**Re: Errata to Remedial Investigation and Feasibility Study (RI/FS) Work Plan, Revision 1; and Response to NDEP Comments dated April 25, 2014, on the RI/FS Work Plan, Revision 1; Nevada Environmental Response Trust Site, Henderson, Nevada (NDEP Facility ID #H-000539)**

**Responses to NDEP Comments Dated April 25, 2014  
Remedial Investigation and Feasibility Study Work Plan, Revision 1,  
Nevada Environmental Response Trust Site, Henderson, Nevada**

**Remedial Investigation and  
Feasibility Study Work Plan  
Revision 2**

**Groundwater Extraction and Treatment System (GWETS) Flow Diagram**  
 Nevada Environmental Response Trust (NERT)  
 Henderson, Nevada

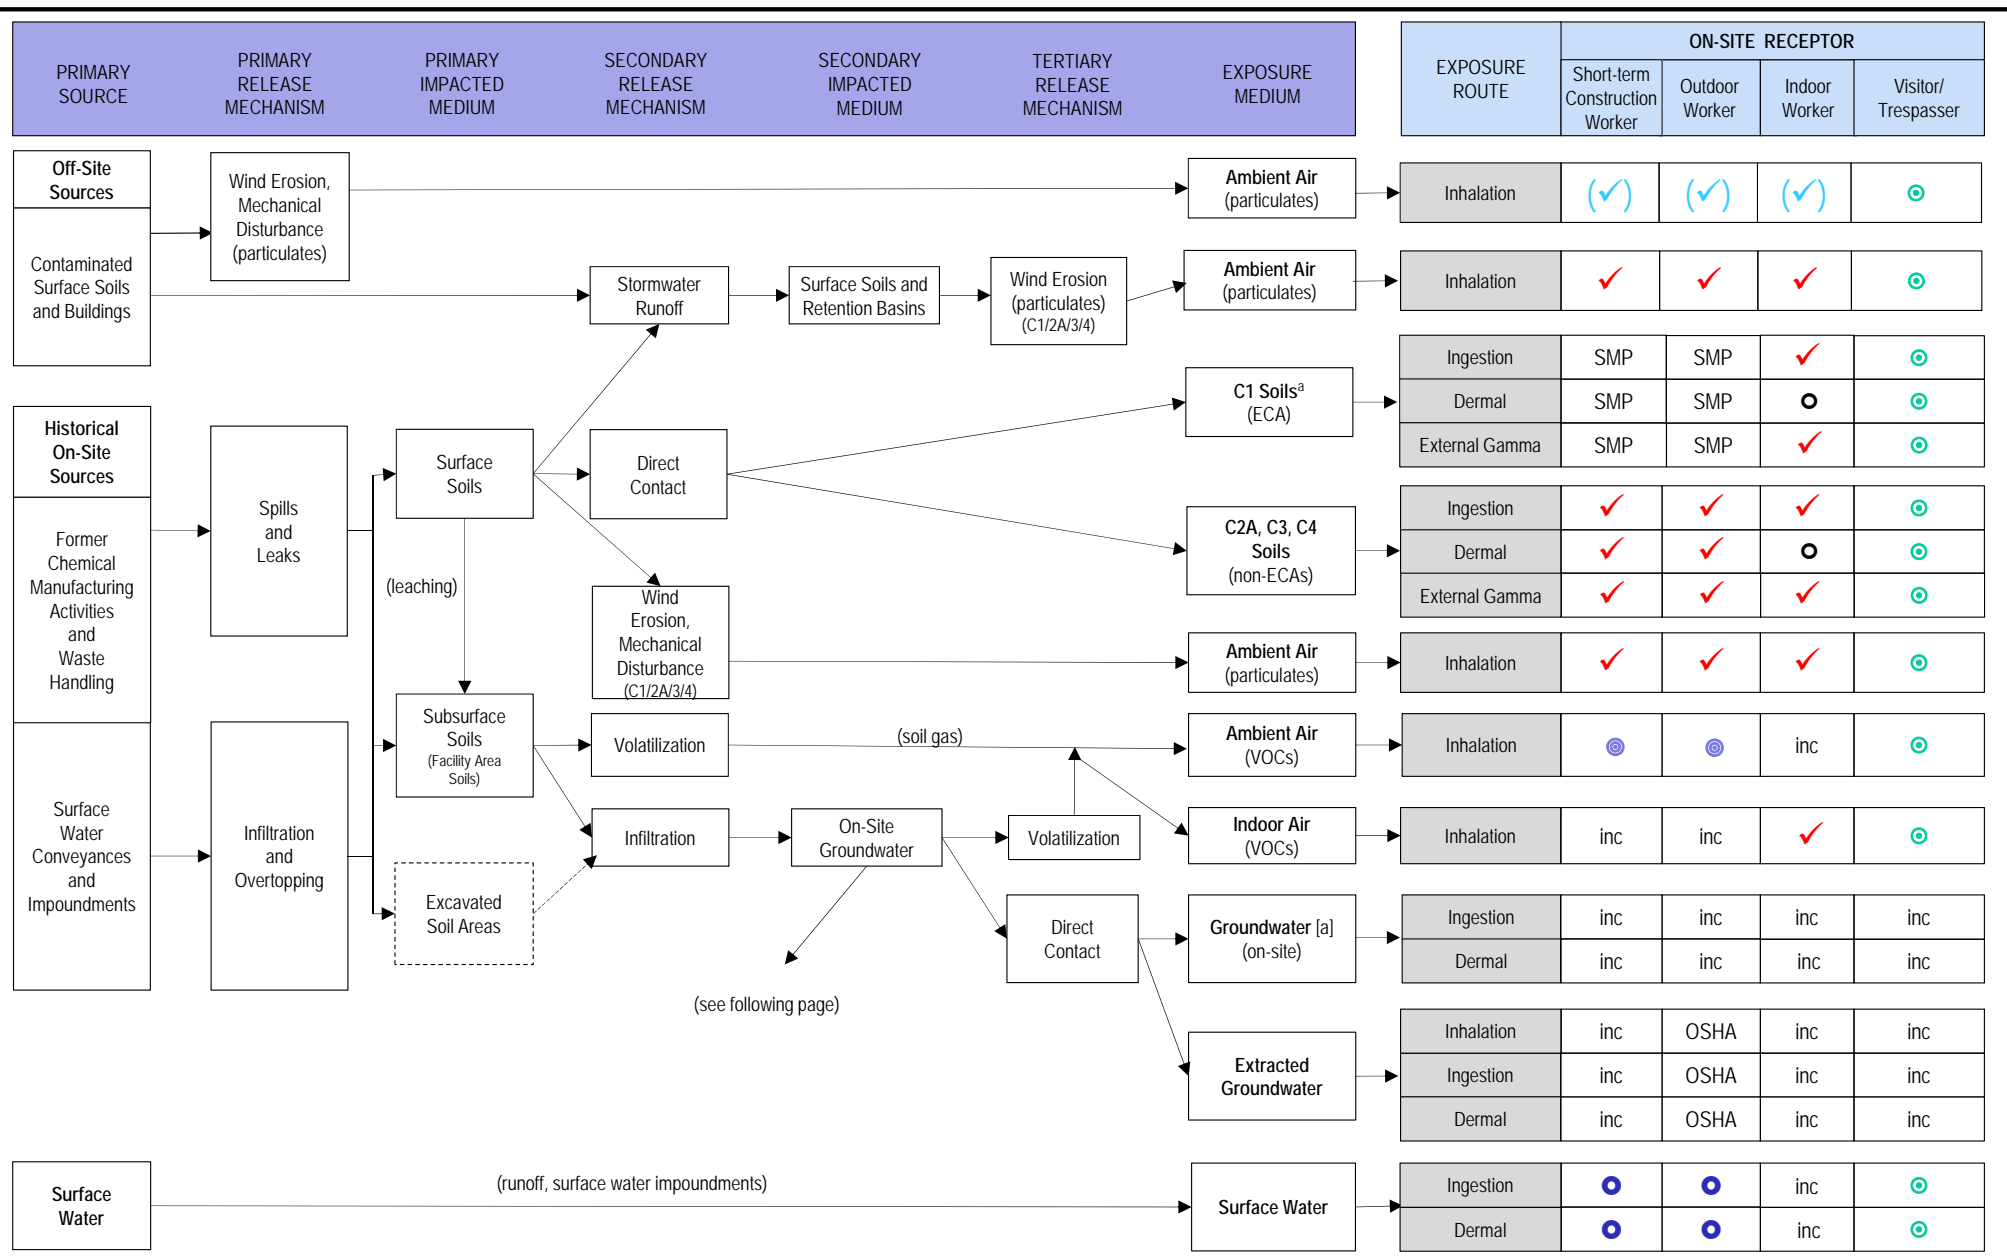
- Revised Figure 4-1 to reflect GW-11's current use as an equalization basin.
- Revised Table 5-1 to address NDEP Comment #3
- Revised Figure 5-4 to address NDEP Comment #2

**Conceptual Site Model Diagram: Facility Area and Downgradient Plume**  
 Nevada Environmental Response Trust Site, Henderson, Nevada

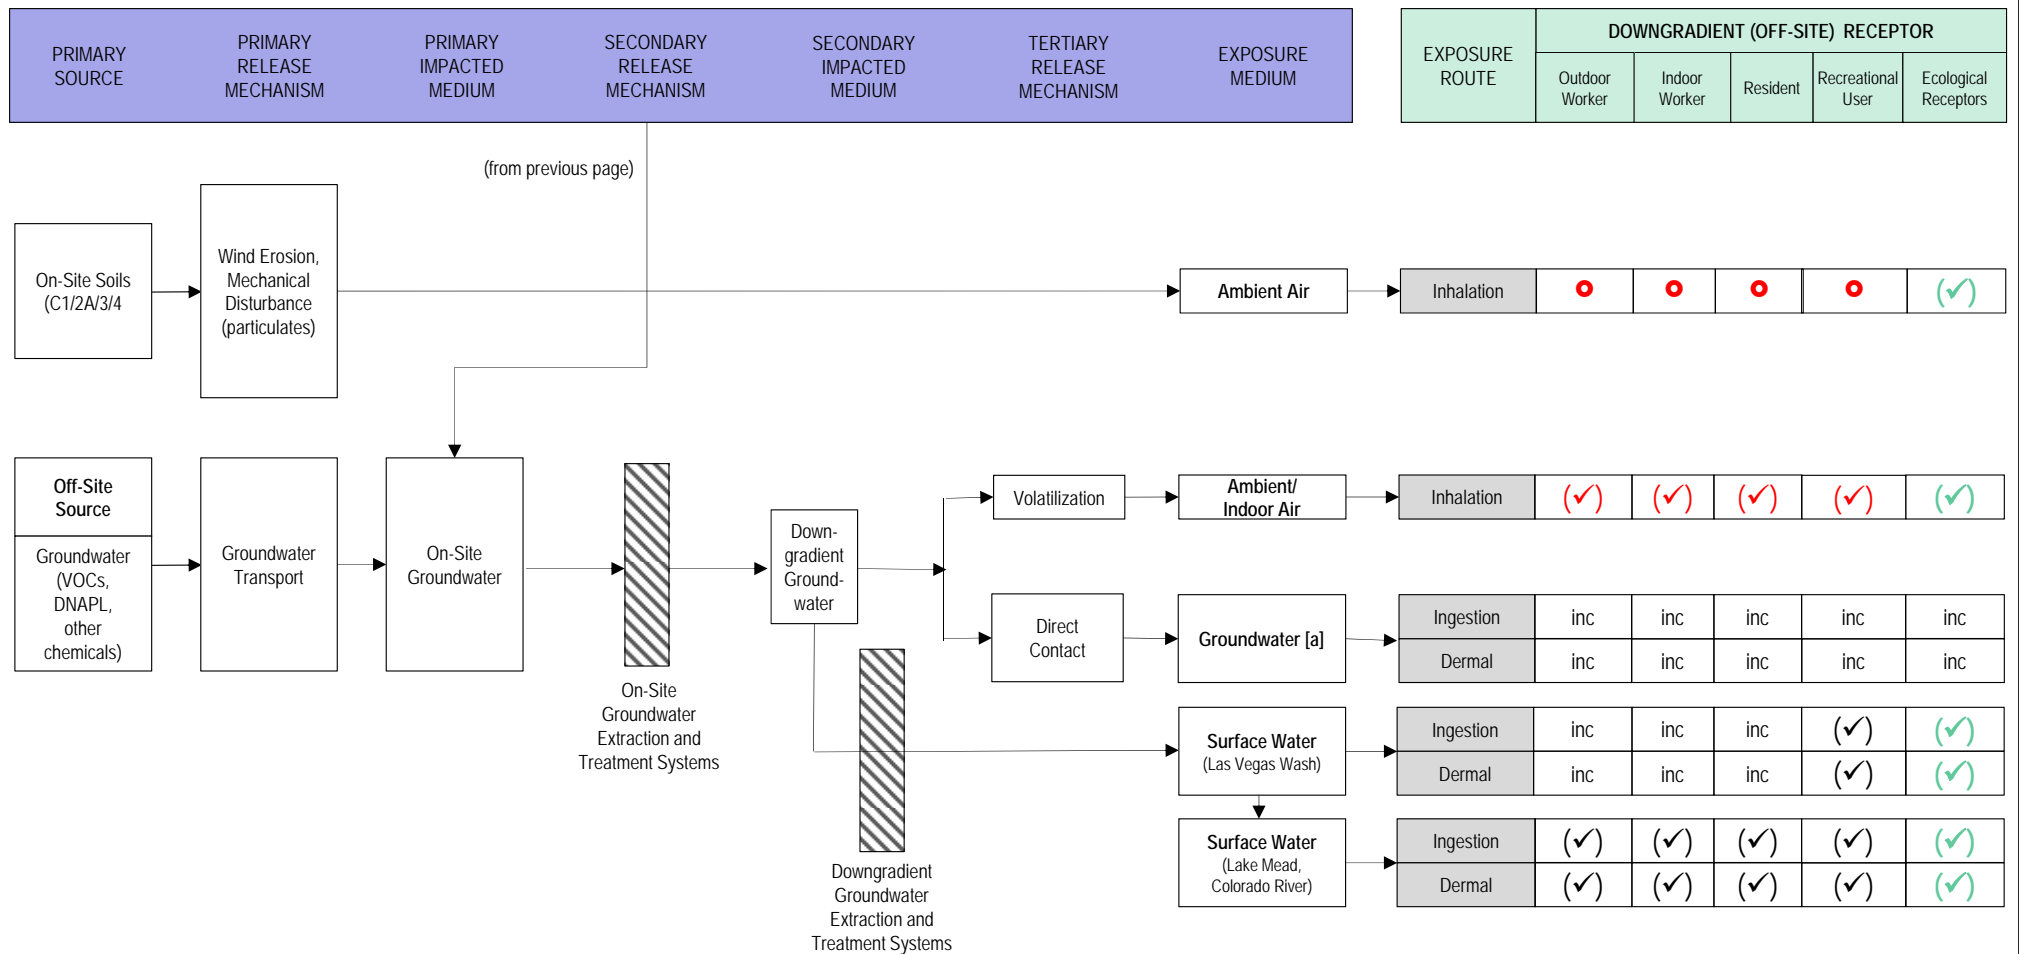
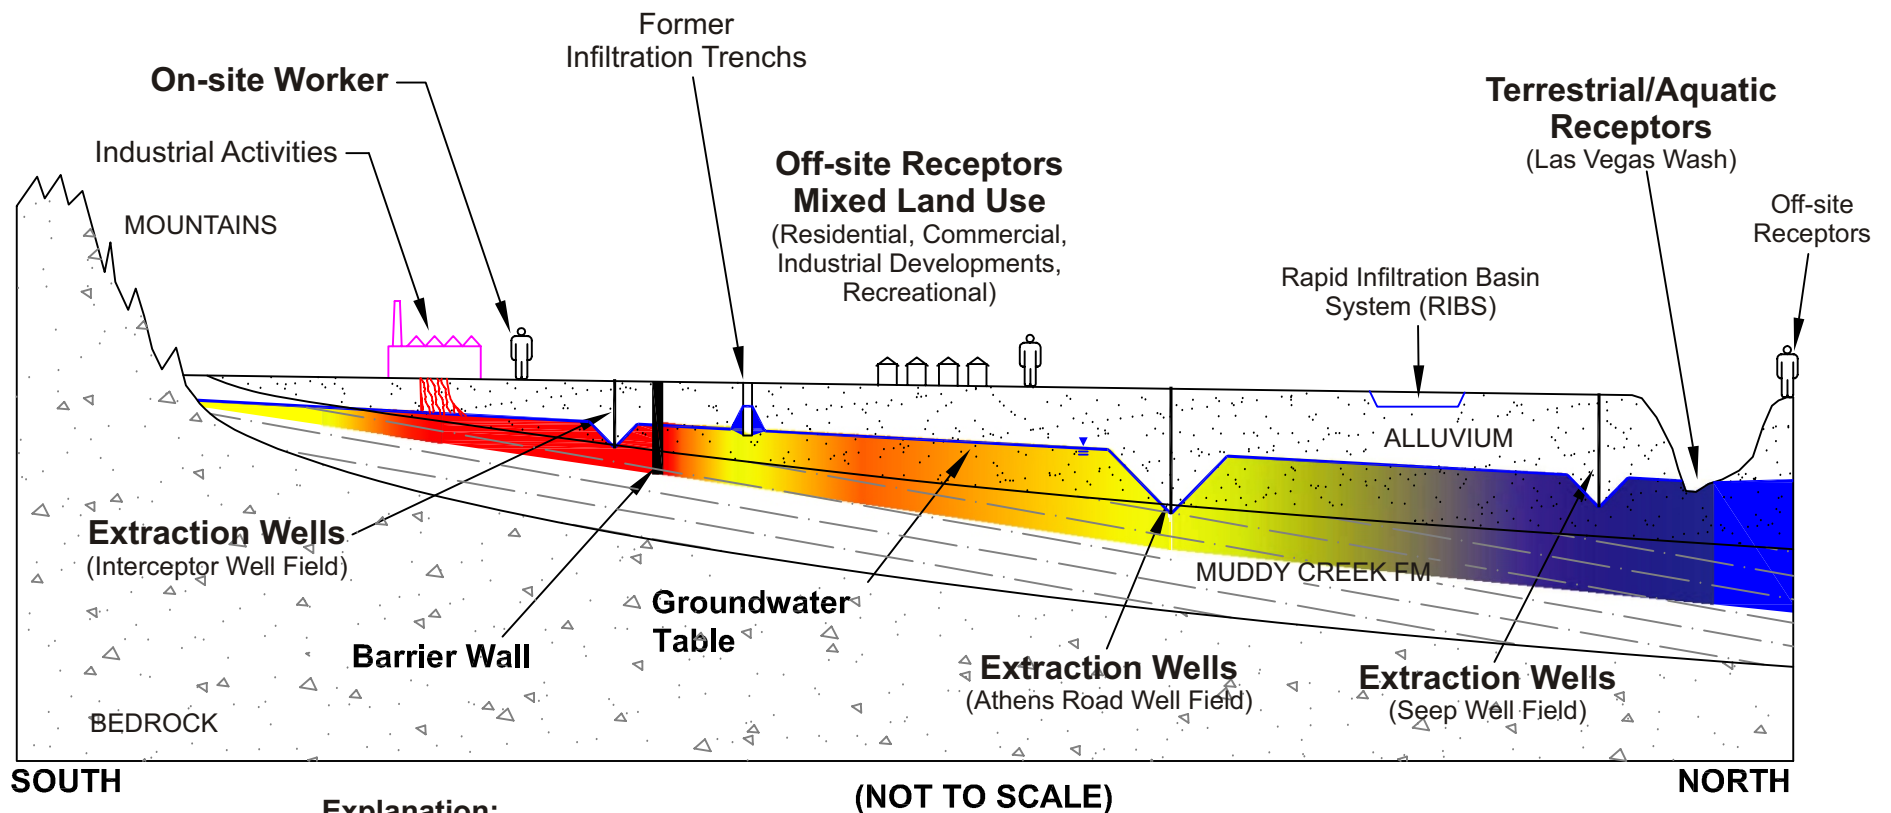
- Revised Figure 5-1 to address NDEP Comment #2 in their letter dated May 20, 2014 regarding the Baseline Health Risk Assessment Work Plan, Revision 0 for the NERT Site

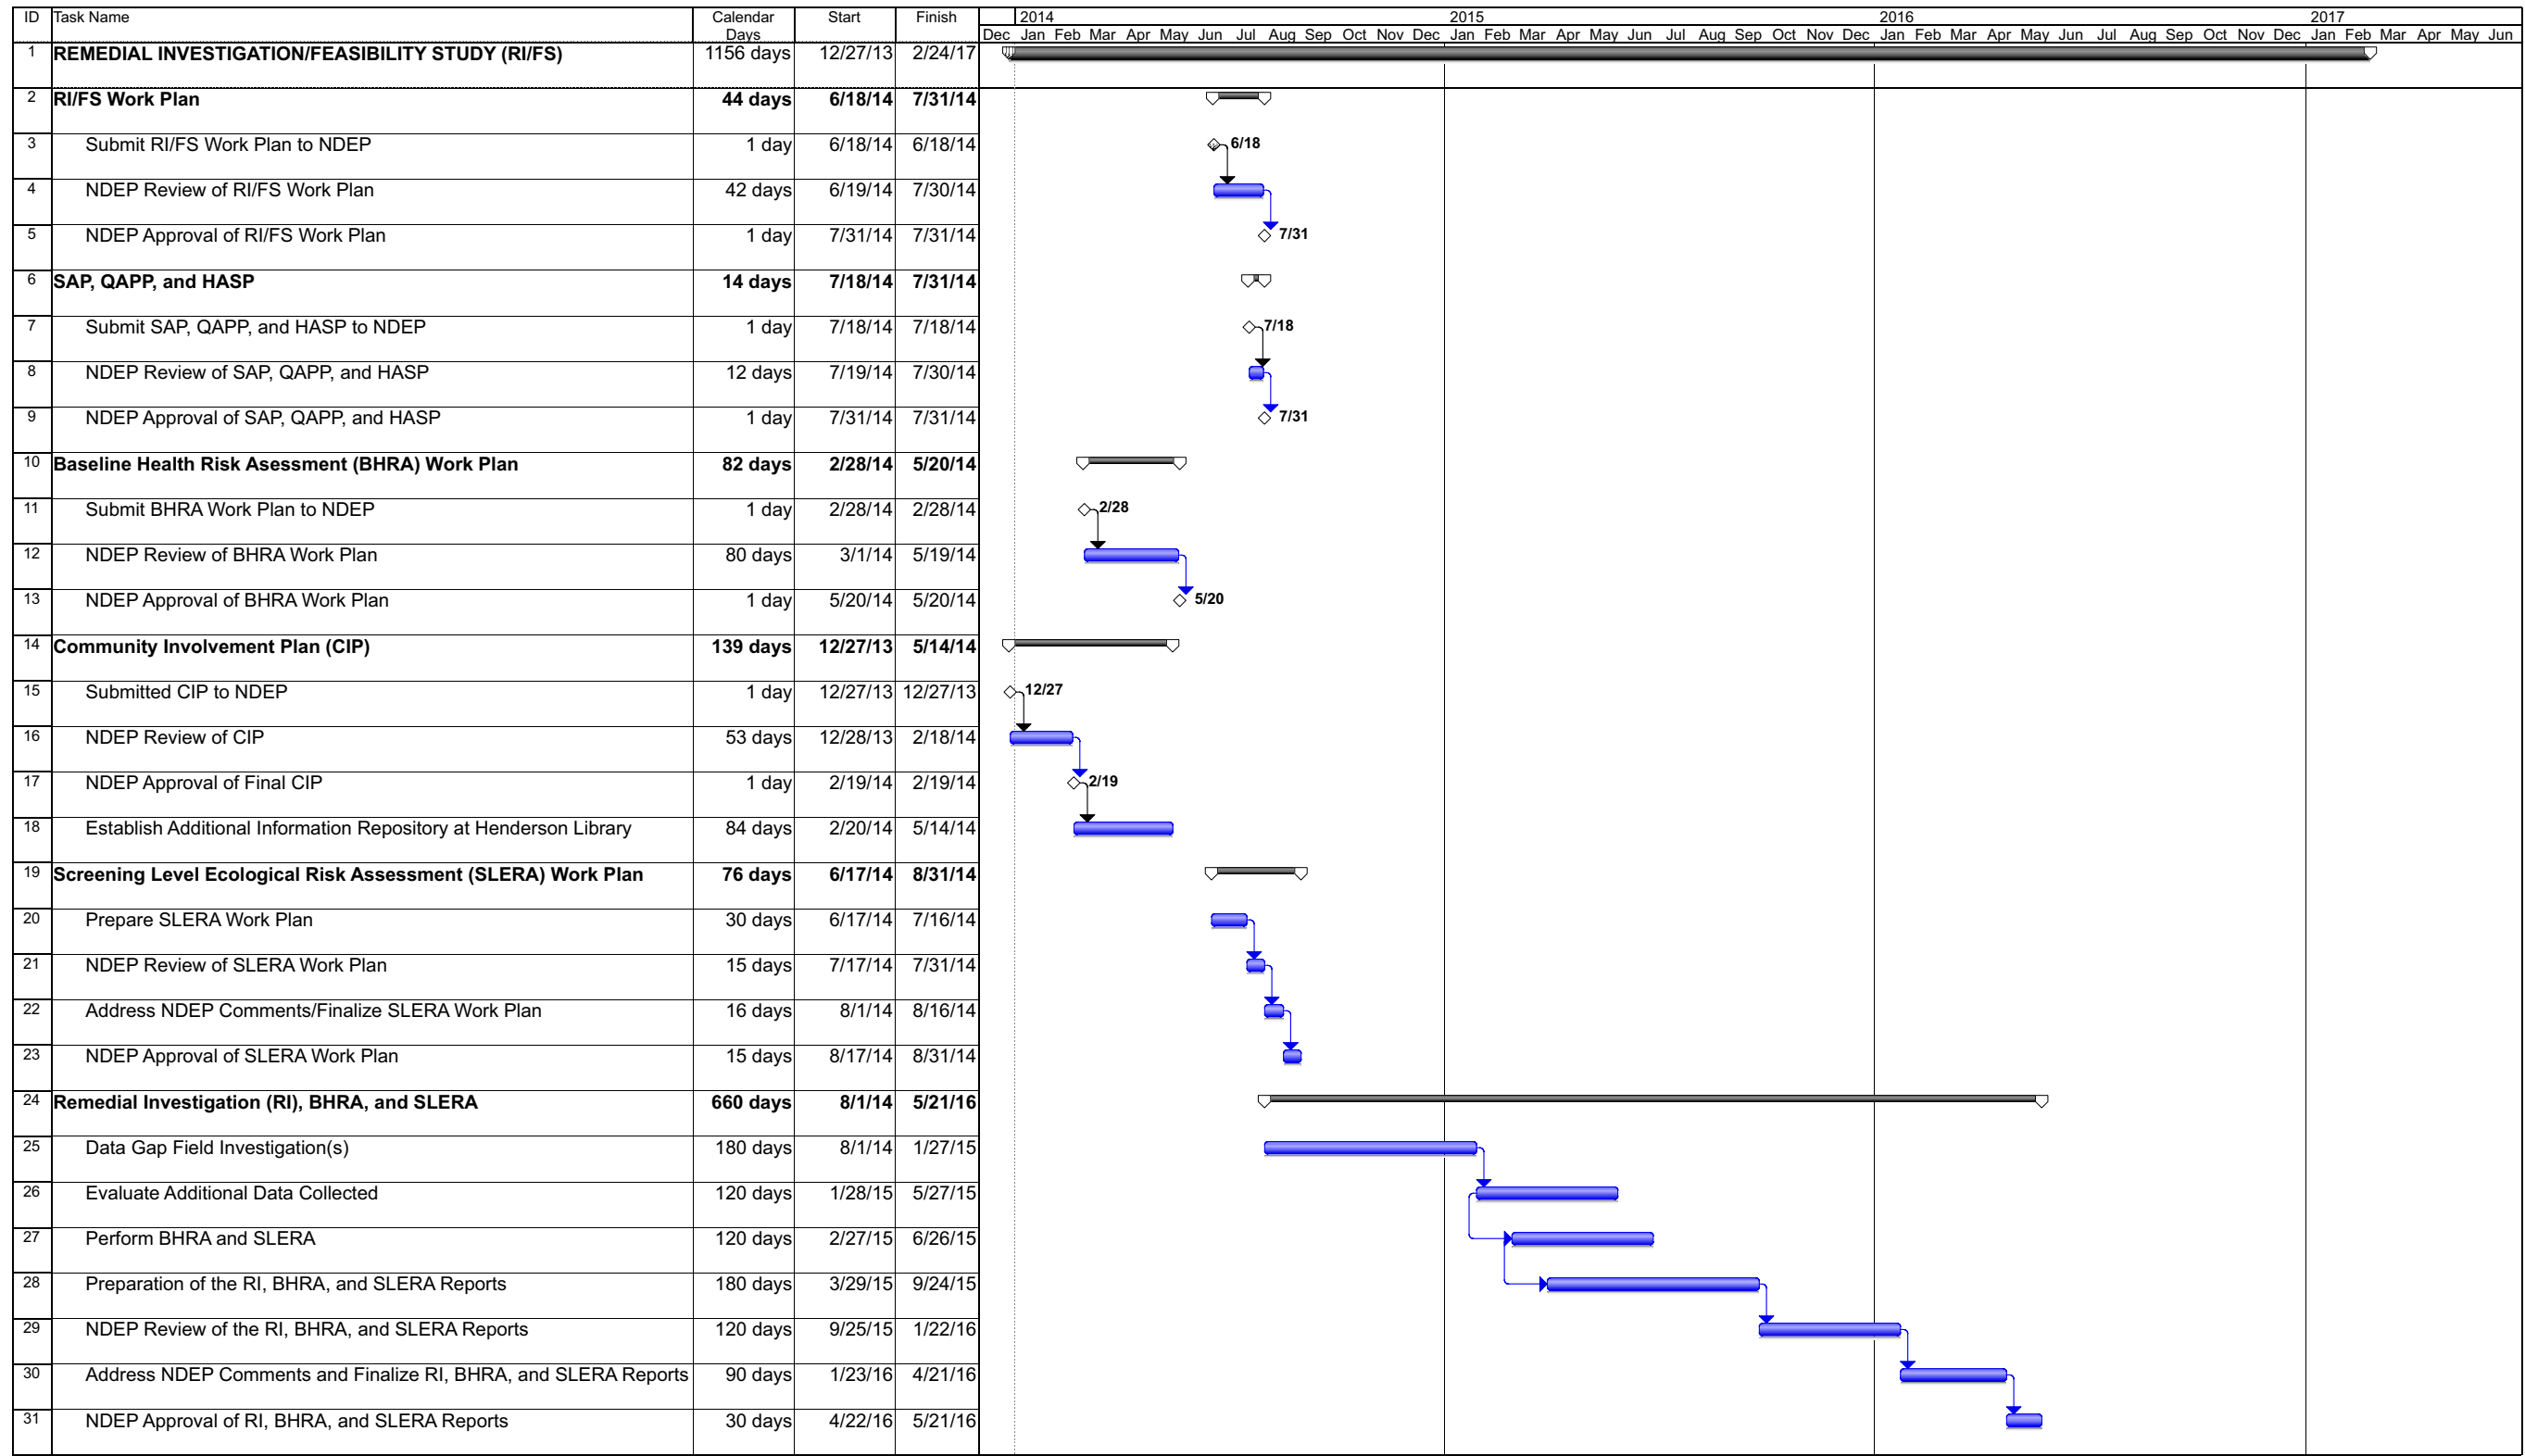
NDEP Comment	Response
<p>1. General Comment. Out-of-state MCLs should not be included in the RI/FS work plan for development of the RAOs. The NERT may consider the out-of-state MCLs as To-Be-Considered Standards (TBCs) for development of the RAOs.</p>	<p>Based on discussions with NDEP, section 5.2.2 of the Work Plan has been revised to include discussion of California and Arizona MCLs, and replacement pages of the text are provided in the errata submitted along with this response to comments.</p>
<p>2. Comment #76, NDEP requested clarification to Figure 5-4. In the response, ENVIRON agreed to revise Figure 5-4. However, the figure that was included in Revision 1 of the RI/FS Work Plan (January 10, 2014) is identical to the original figure.</p>	<p>A revised version of Figure 5-4 with language added to the figure to address NDEP's Comment #76, was provided in the revised Work Plan, dated January 10, 2014. We apologize if the copy of the work plan submitted to NDEP did not have the updated figure. The updated figure is provided in the errata.</p>
